Dean Moor Solar Farm

Environmental Statement: Appendix 7.8 – Arboricultural Impact Assessment

Deadline: 2

Revision: ~~21~~

Appendix C Tree Protection Plan

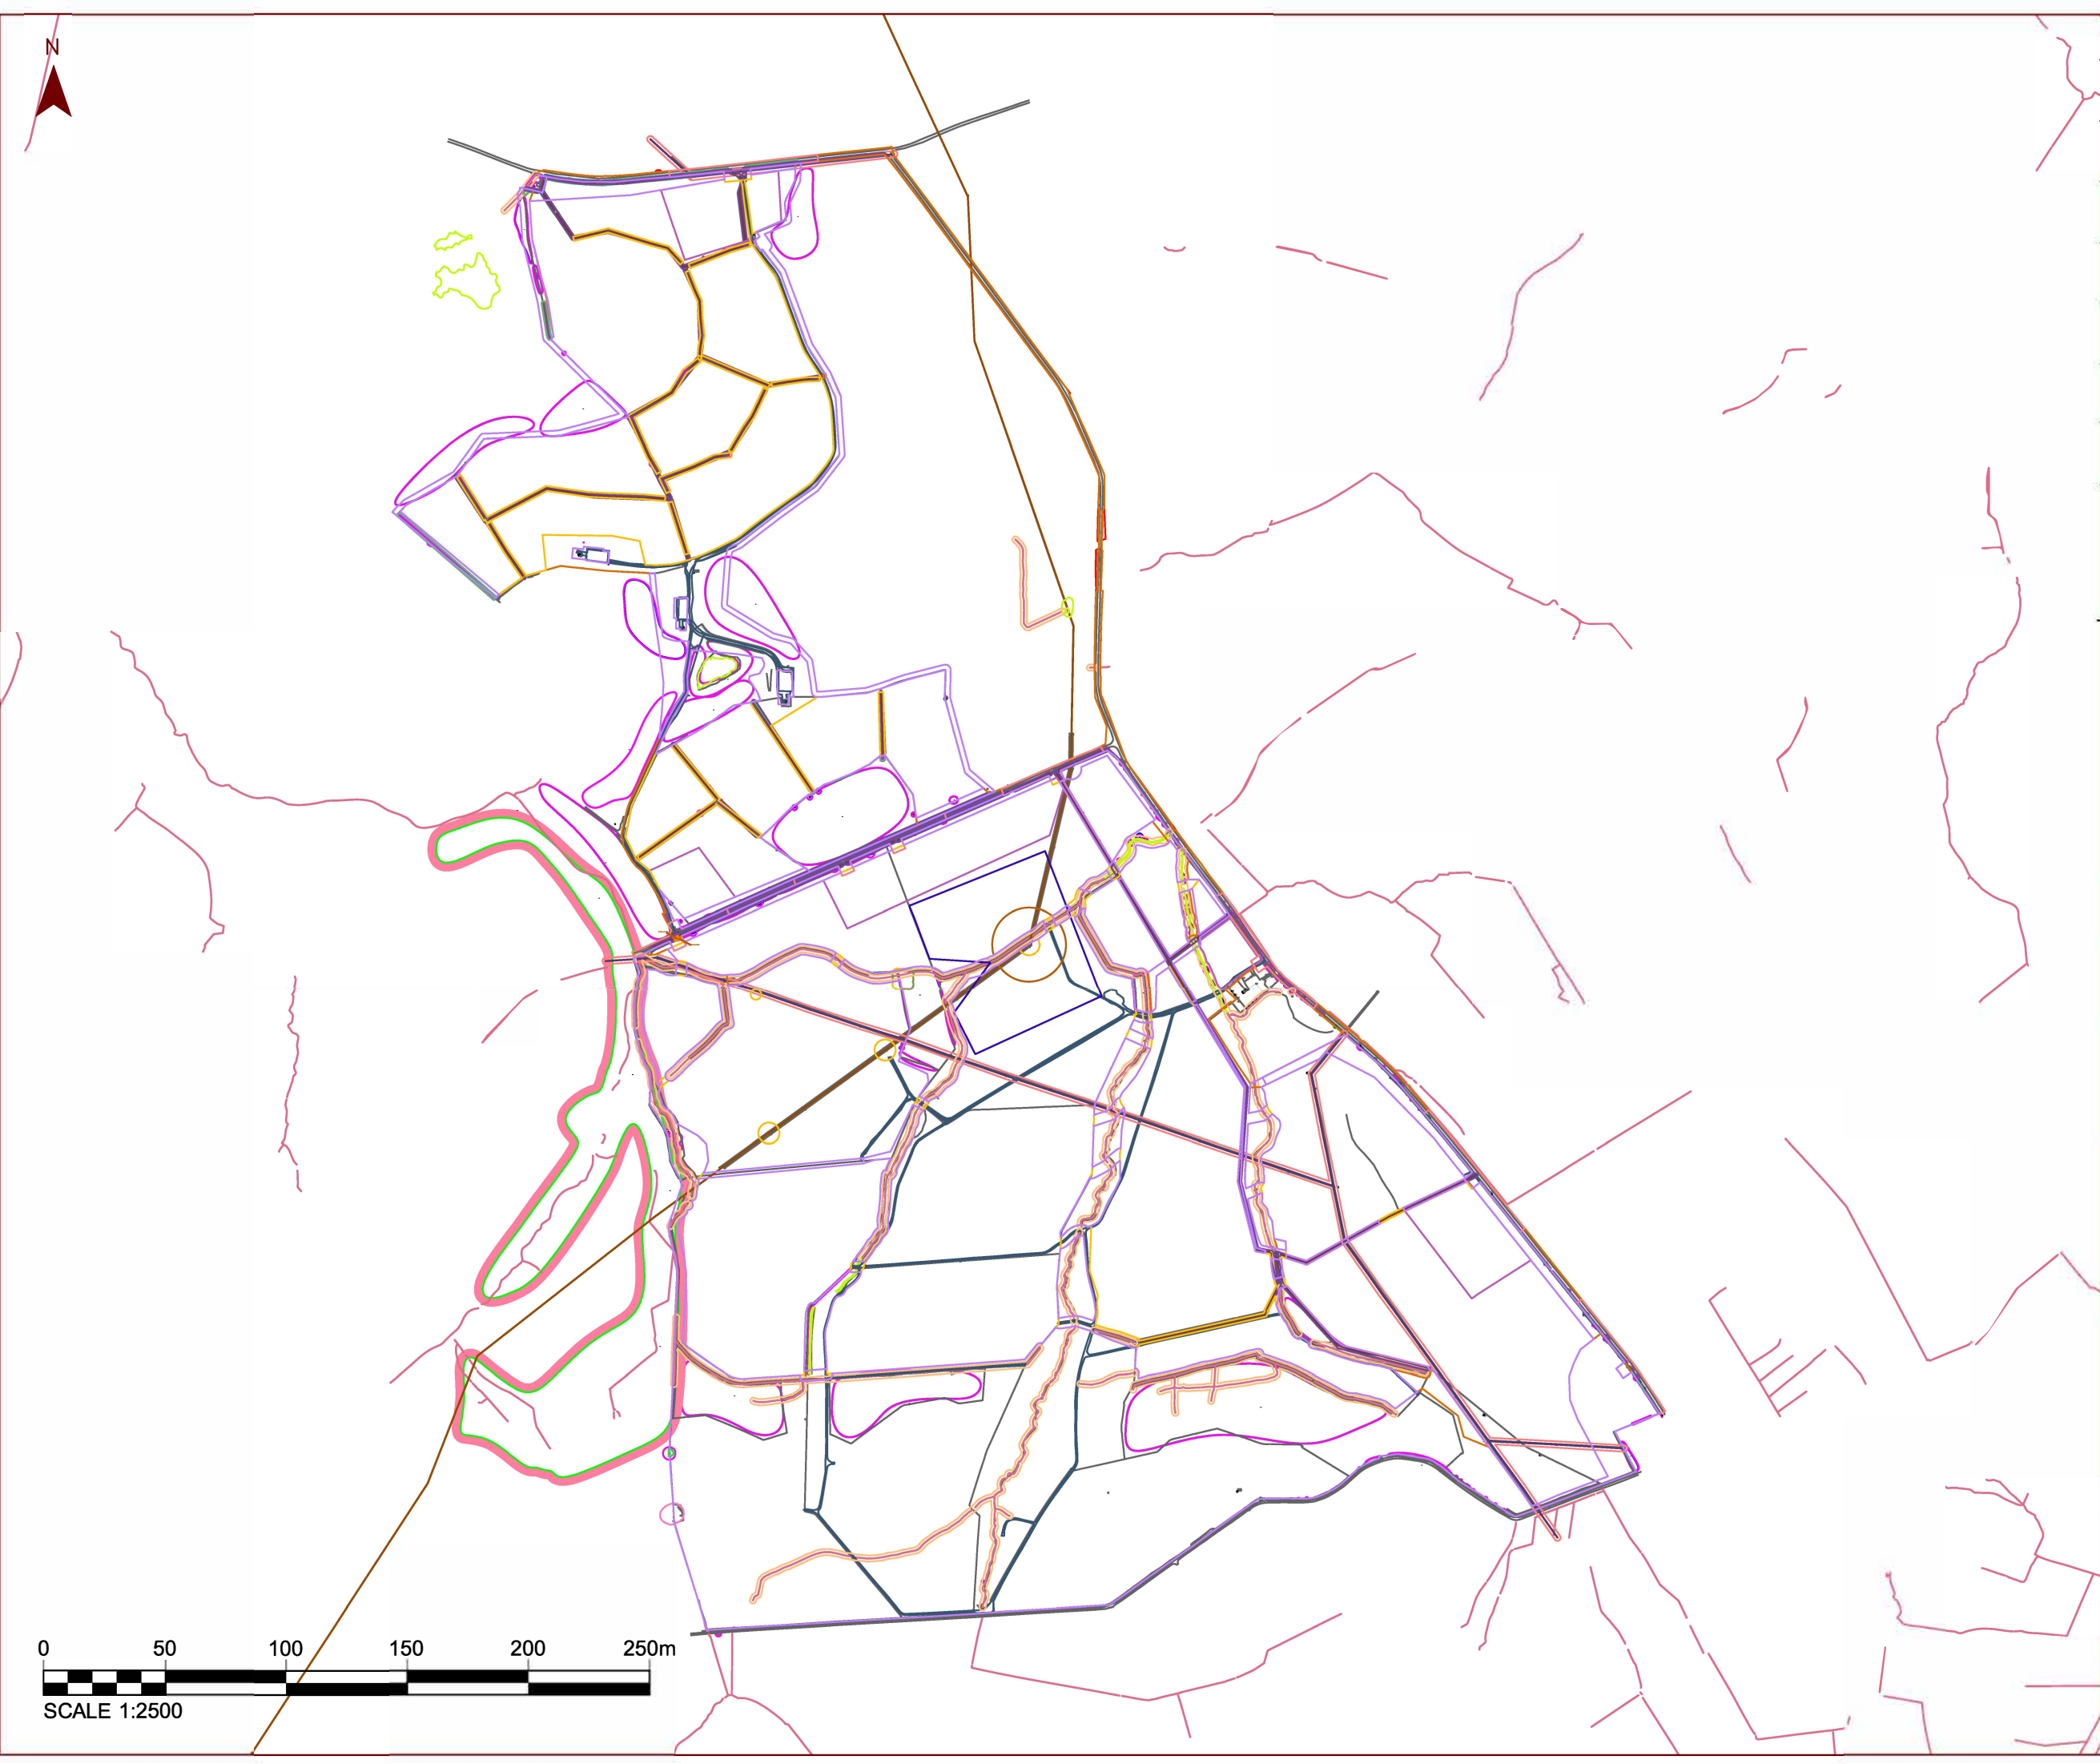
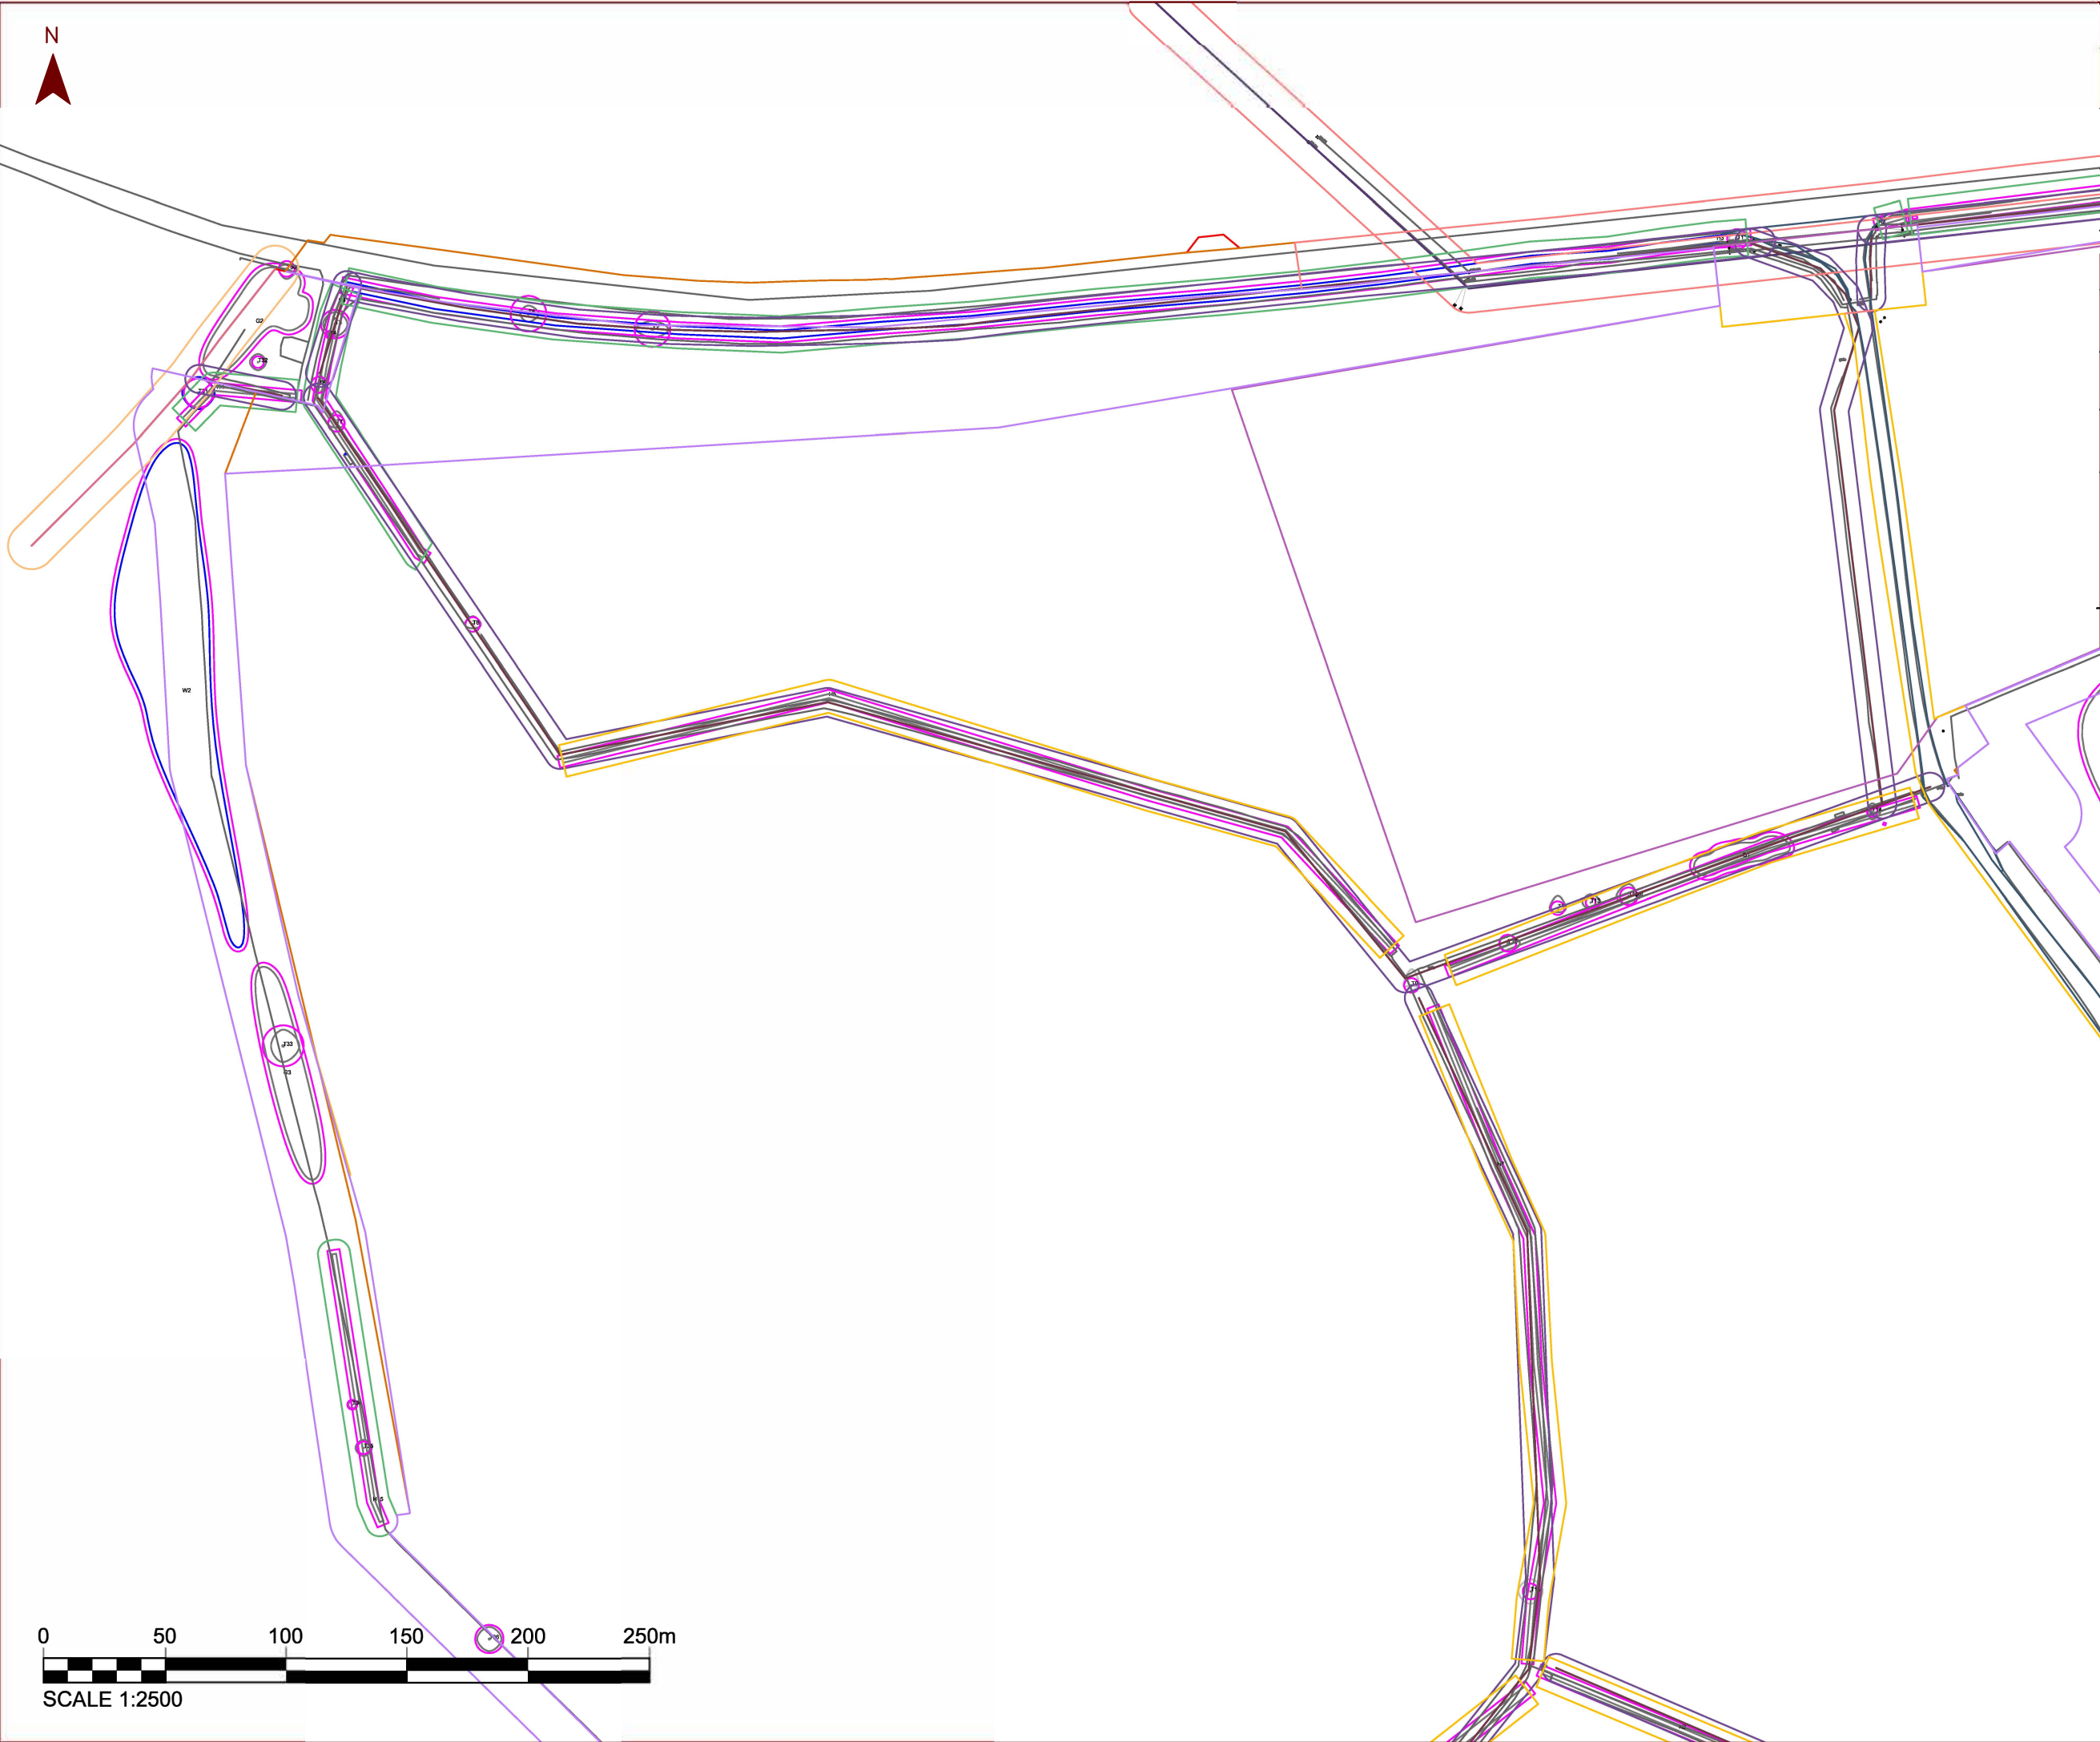
Revision	Reason
Change of the plan title in the TCP from 'Location Plan' to 'Tree Constraints Plan'	To make it clear that the plan is displaying the TCP. As the Location Plan is a different figure within the ES.
A renumbering of the sheets included in the TCP. Changing the order from 0-22 to 1-23.	To enable the first sheet within the TCP is numbered 1 rather than 0.
Change of the plan title in the TPP from 'Location Plan' to 'Tree Protection Plan'	To make it clear that the plan is displaying the TPP. As the Location Plan is a different figure within the ES.
A renumbering of the sheets included in the TPP. Changing the order from 0-22 to 1-23.	To enable the first sheet within the TPP is numbered 1 rather than 0.
